**HUGHES
SERVICE INFORMATION
LETTER**

LETTER NO. L-72

SUBJECT: LYCOMING SERVICE INSTRUCTION NO. 1255, DATED 4 AUGUST 1972 -
SUBJECT: THERMOSTATIC OIL COOLER BYPASS VALVE
REPLACEMENT

Service Instruction

Temperature Control and Oil Cooler Bypass Valves

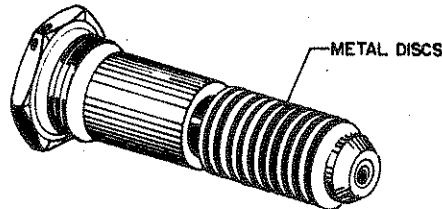
The illustration shows the difference in construction of the thermostatic oil cooler bypass valve P/N 75944 and its alternate P/N LW-10269.

It has been determined that the alternate valve LW-10269 does not function properly in some instances. Therefore, it is recommended that the thermostatic bypass valve LW-10269 be replaced by 75944 immediately if high oil temperatures have been encountered or at the next 100 hour inspection to forestall any possible future high temperature malfunction.
